LINCOLN/LANCASTER COUNTY PLANNING STAFF REPORT

for November 23, 2005 PLANNING COMMISSION MEETING

PROJECT #: Annexation #05014
Change of Zone #05061 - AG and AGR to B-2 PUD
Change of Zone #05062 - AG and AGR to R-3 and R-4

PROPOSAL: Annexation and a change of zone for a B-2 planned unit development for approximately 1,300,000 square feet of office, commercial, and industrial floor area and approximately 150 dwelling units.

SHEET
05 OF 21

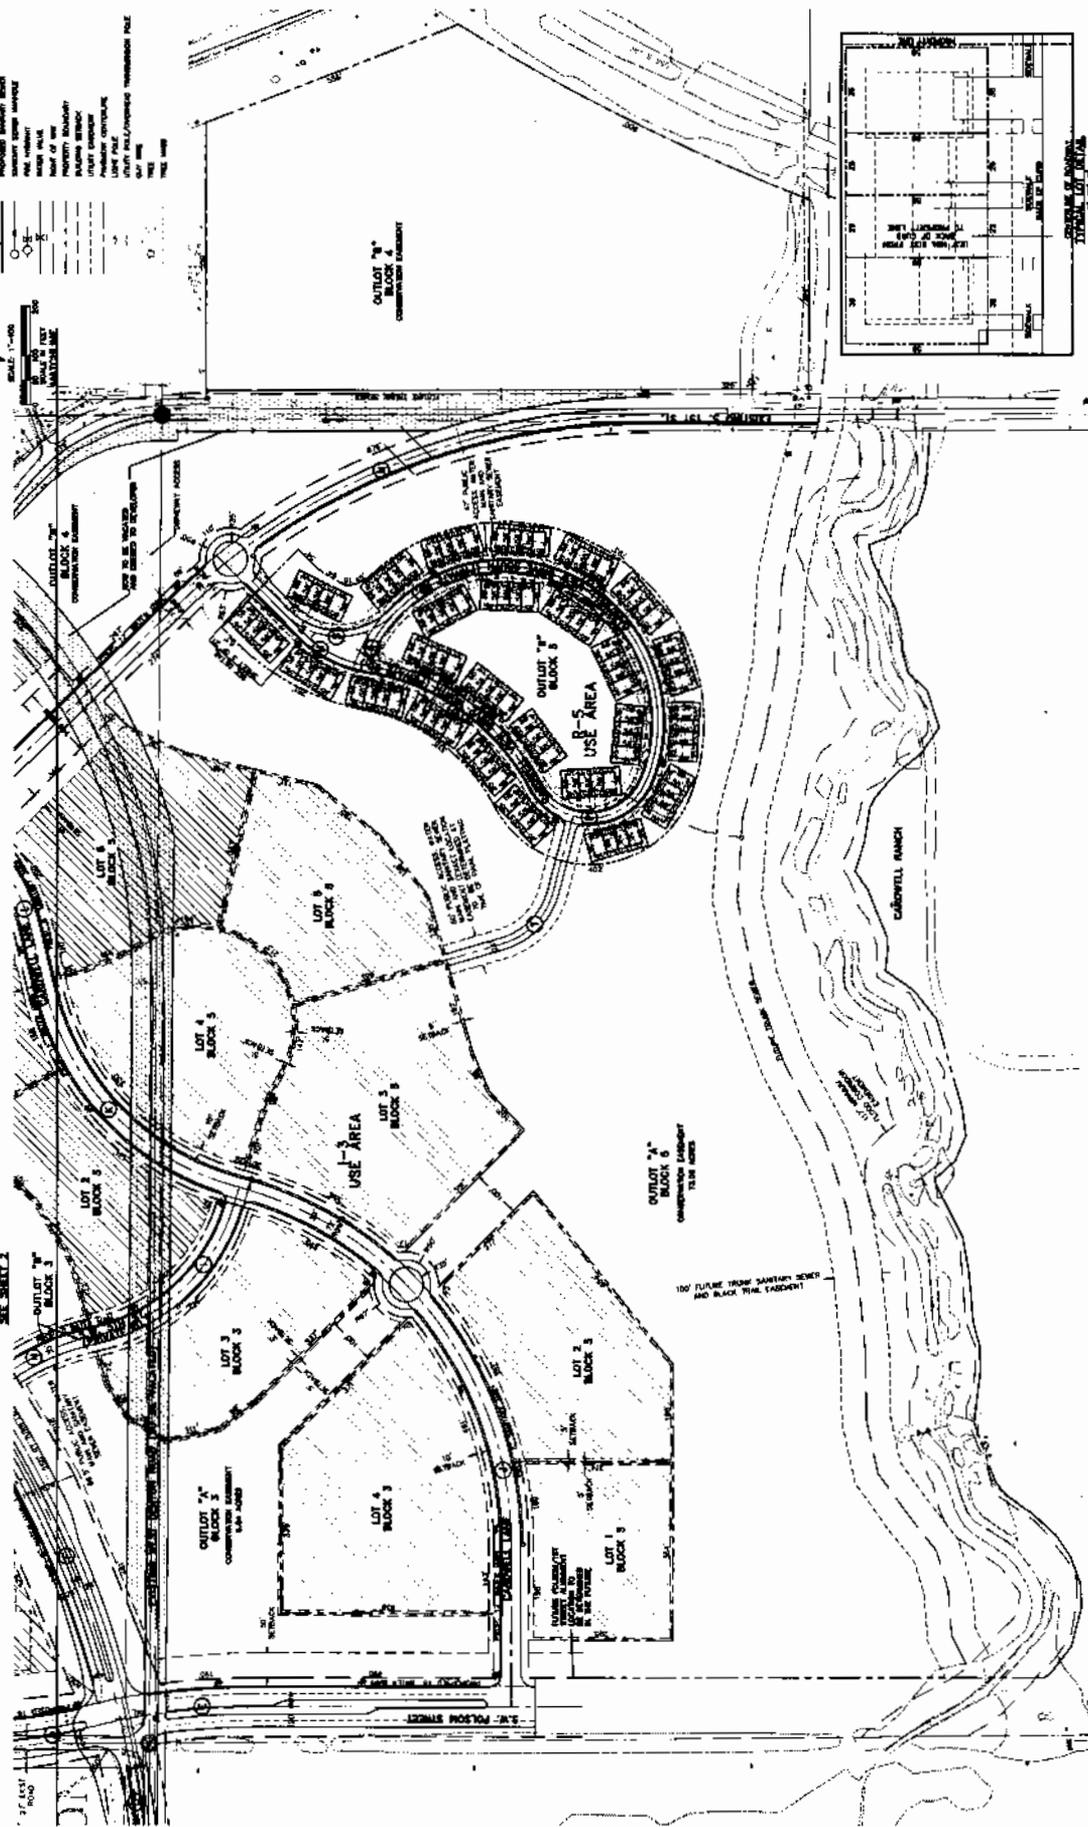
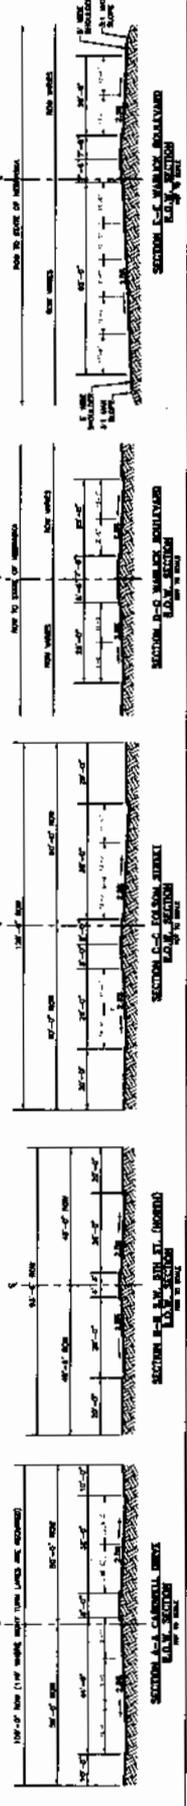
- 1.1.15 Revise the typical lot detail for the townhouses on Sheet 3 of 21 to show a dimension of 22' from the back of sidewalk to the garage.
- 1.1.16 Revise General Note #8 to read as follows: SIDEWALKS TO BE BUILT ALONG BOTH SIDES OF ALL PUBLIC STREETS AND PRIVATE ROADWAYS.”
